QUALITY ASSURANCE -- NON-CONFORMANCE REPORT

Report No: NCR-000401

Reference Description: Missed MT indications on South Tower, Lift 3, Skin A Padeyes

To: AMERICAN BRIDGE/FLUOR, A JV **Date:** 07-Sep-2009
 375 BURMA ROAD
 OAKLAND CA 95607 **Contract No:** 04-0120F4
 04-SF-80-13.2 / 13.9
Dear: Mr. Charles Kanapicki **Job Name:** SAS Superstructure
Attention: Mr. Thomas Nilsson Project/Fabrication Manager **Document No:** 05.03.06-000363
Subject: NCR No. ZPMC-0375
Reference Description: Missed Indications (MT) / South Shaft Lift 3 Skin A / Padeye Weld

Welding	Concrete	Other	
Welding	Curing	Procedural	Bridge No: 34-0006
Joint fit-up	Coating	Other	Component: South Tower
Procedural	Procedural	Description: South Tower, Lift 3, Skin A Padeyes

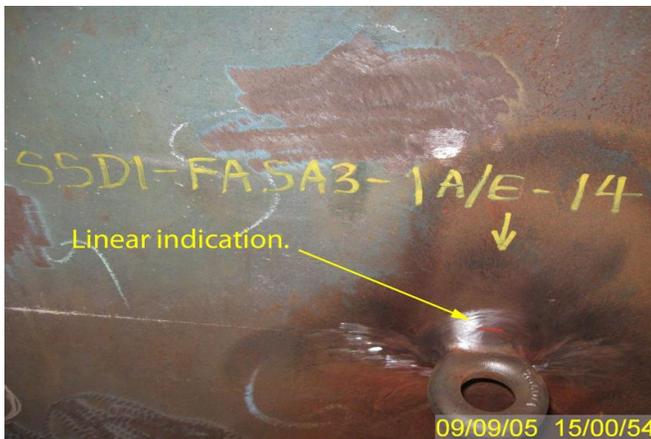
During Magnetic Particle Testing (MT) of South Tower, Lift 3, Padeye weld SSD1-FASA3-1A/E-14, QA discovered two linear indications approximately 15 and 12mm in length. This weld was previously tested and accepted by ZPMC NDT personnel.

Procedural Procedural Description: South Tower, Lift 3, Skin A Padeyes

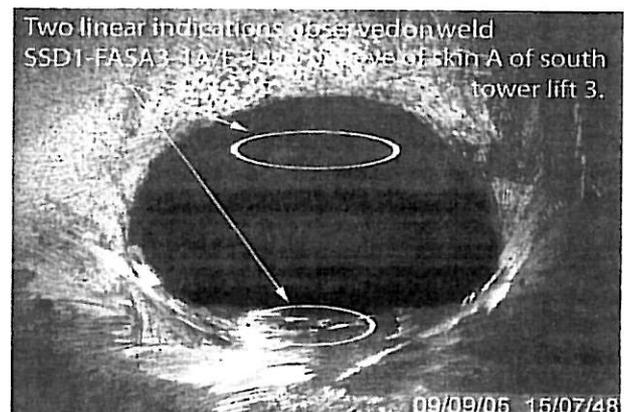
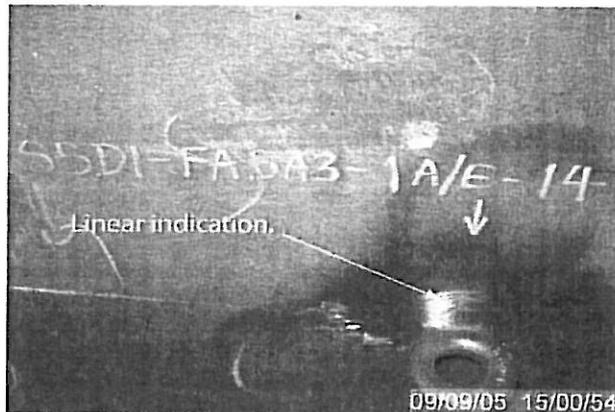
During Magnetic Particle Testing (MT) of South Tower, Lift 3, Padeye weld SSD1-FASA3-1A/E-14, QA discovered two linear indications approximately 15 and 12mm in length. This weld was previously tested and accepted by ZPMC NDT personnel.

WELD NUMBER:SSD1-FASA3-1A/E-14

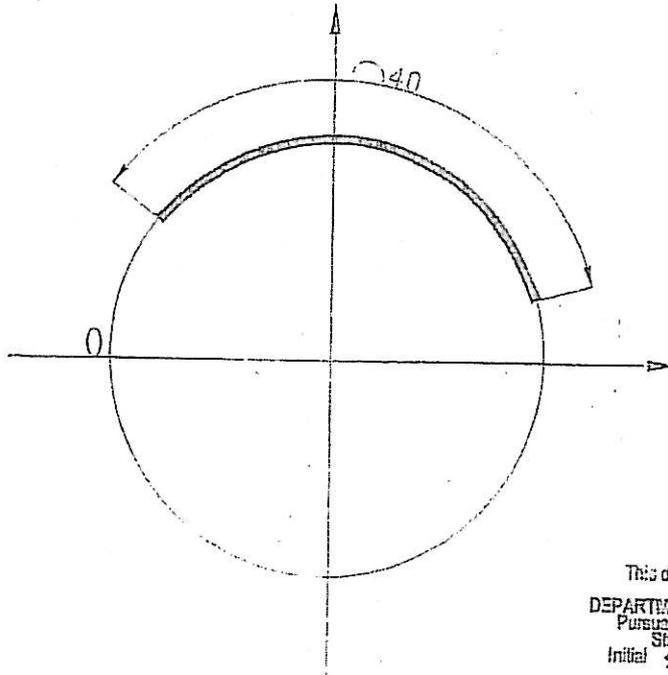
One line indication was found by use of MT on SSD1-FASA3-1A/E-14.

1. 火焰加热时, 水汽没有完全的去除或者这个区域预热不够;
1. Moisture wasn't completely removed during drying operation (preheating) or the area wasn't preheated sufficiently.

1. QC shall monitor and direct the welder and the grinder doing the repair operation.
 2. Preheat before gouging; the temperature shall be at least 65°C.

3. Gouge the weld to remove identified defects.
 4. Joint details shall refer to the approved WPS repair.
 5. Grind the gouged areas to a smooth and shiny surface.

6. Verify with VT and MT to ensure no defects remain in the weld joint prior to welding.
 7. QC shall monitor all welding passes being deposited.
 8. QC shall ensure all slag has been removed prior the deposition of next pass.

9. Preheat and maintain interpass temperature control in accordance with the WPS.
 10. Blend the weld repaired areas into the adjacent weld or base metal by grinding.

1. QC shall verify sufficient preheat has been applied, to remove moisture, prior to welding.

Reference Description: Missed MT indications on South Tower, Lift 1, Skin A & B Pad Eyes

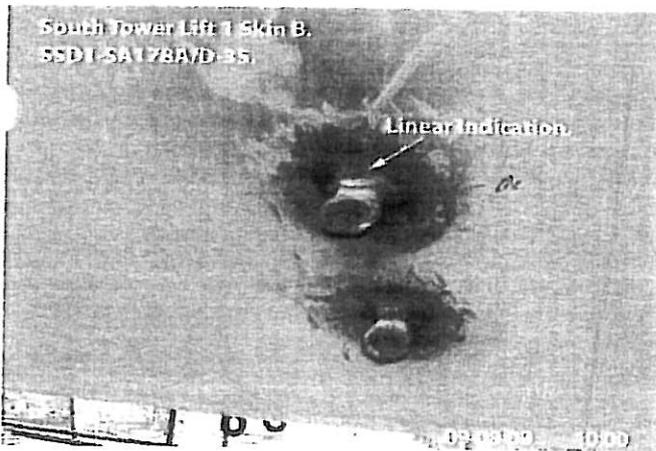
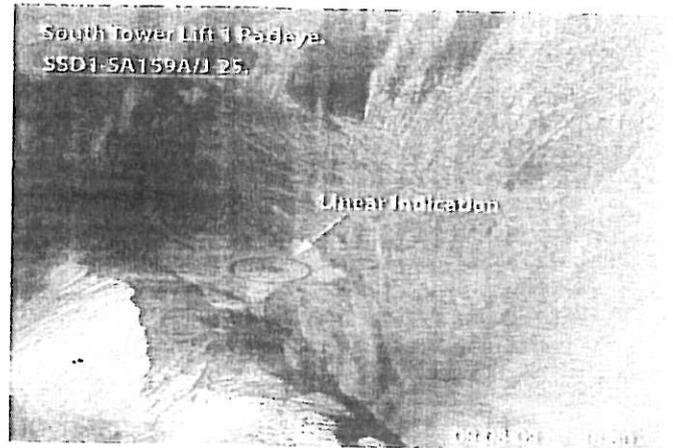
During Magnetic Particle Testing (MT) of South Tower, Lift 1, Skin A pad eyes, QA observed linear indications at weld joints SSD1-SA159A/J-25 & SSD1-SA159A/J-28. ZPMC MT Technicians had previously tested and accepted 10% of the pad eye welds. After QA found the linear indications, ZPMC QC personnel Zhang Jiadi asked to cancel the request for QA inspection in order to perform 100% MT of remaining pad eyes.

Following ZPMC's testing and acceptance of 100% of the pad eye welds, QA performed MT and discovered linear indications at weld joints SSD1-SA159A/J-24 & SSD1-SA178A/D-35.

A面: SSD1-SA159B/J-24, 25, 28

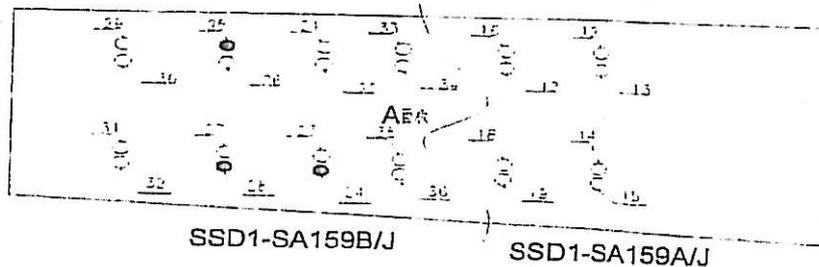
Tower(S) first lifting, the cracks were found on three lifting ring on Skin A and one lifting on Skin B, weld ID : Skin A:SSD1-SA159B/J-24, 25, 28, Skin B SSD1-SA178A/D-35.

1. 火焰加热时, 水汽没有完全的去除或者这个区域预热不够;
1. Moisture wasn't completely removed during drying operation (preheating) or the area wasn't preheated sufficiently.

3. QC shall monitor and direct the welder and the grinder doing the repair operation.
 4. Preheat before gouging; the temperature shall be at least 65°C.

5. Gouge the weld to remove identified defects.
 6. Joint details shall refer to the approved WPS repair.
 7. Grind the gouged areas to a smooth and shiny surface.

8. Verify with VT and MT to ensure no defects remain in the weld joint prior to welding.
 9. QC shall monitor all welding passes being deposited.
 10. QC shall ensure all slag has been removed prior the deposition of next pass.

11. Preheat and maintain interpass temperature control in accordance with the WPS.
 12. Blend the weld repaired areas into the adjacent weld or base metal by grinding.

13. Perform VT, MT inspection to the repaired areas.
- 1、在返修过程中, QC 应该监控和指导焊工和打磨工;
 - 2、碳刨之前必须先进行预热, 温度不低于 65° C;
 - 3、碳刨去除缺陷;
 - 4、缺陷被完全消除后, 必须准备一个正确的接头型式, 具体接头型式请参见对应的修补焊接工艺规程(WPS);
